BRUNSWICK STEAM ELECTRIC PLANT, UNIT NOS. 1 AND 2
DOCKET NOS. 50-325 & 50-324/LICENSE NOS. DPR-71 & DPR-62
FOLLOW-UP QUESTIONS ON SEISMIC QUALIFICATION ISSUES
(TAC NOS. M83211 AND M83212)

BRUNSWICK STEAM ELECTRIC PLANT, UNITS 1 AND 2
NRC DOCKET NOS. 50-325 & 50-324
OPERATING LICENSE NOS. DPR-71 & DPR-62
FOLLOW-UP QUESTIONS ON SEISMIC QUALIFICATION ISSUES
(TAC NOS. M83211 AND M83212)

Figure 3.7.1.5

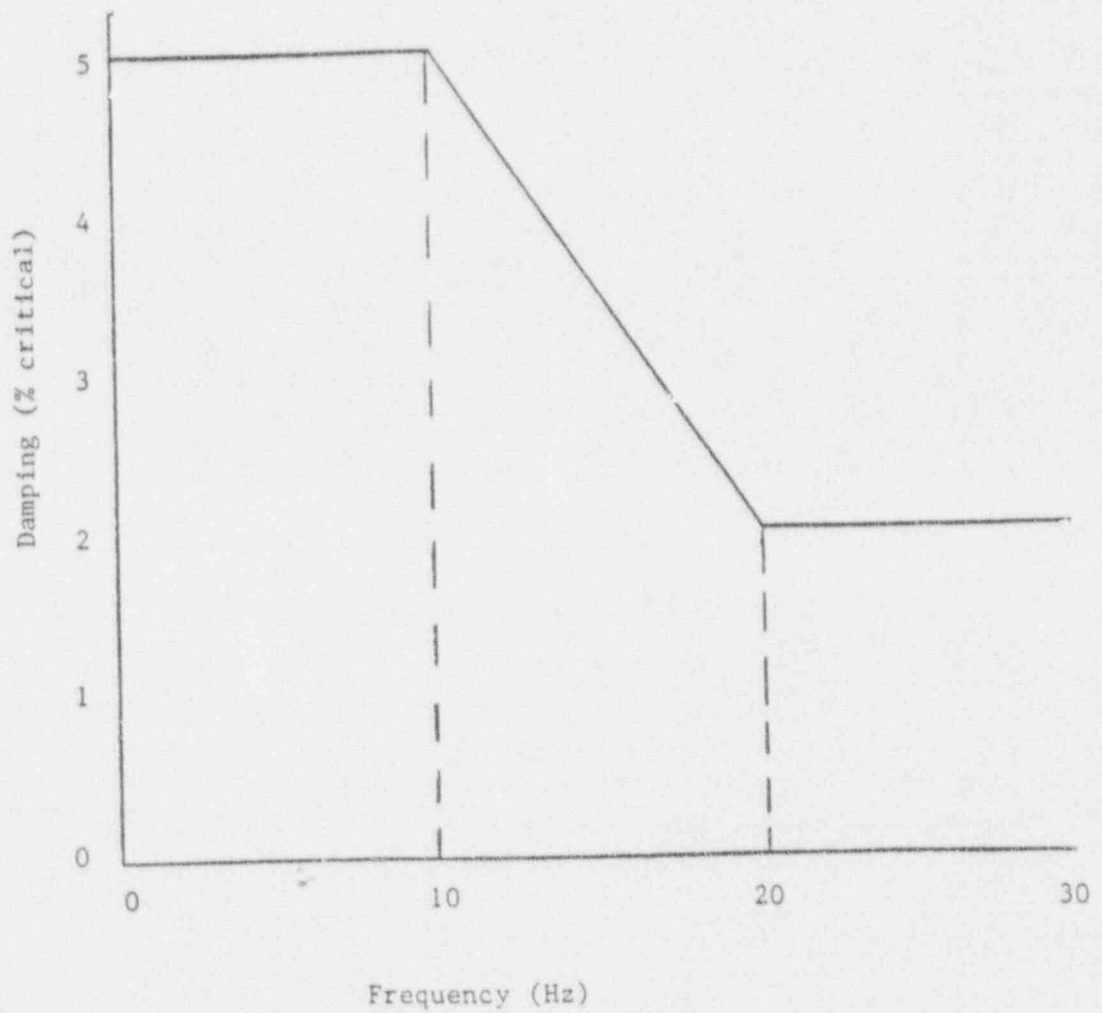
In an attachment to the letter of May 22, 1985, the licensee has included marked up copies of the affected FSAR Tables 3.7.1-1 and 3.7.3-1, page 3.9.2-6 and figure 3.7.1.5 which will be included in the next FSAR revision. The staff finds this material acceptable.
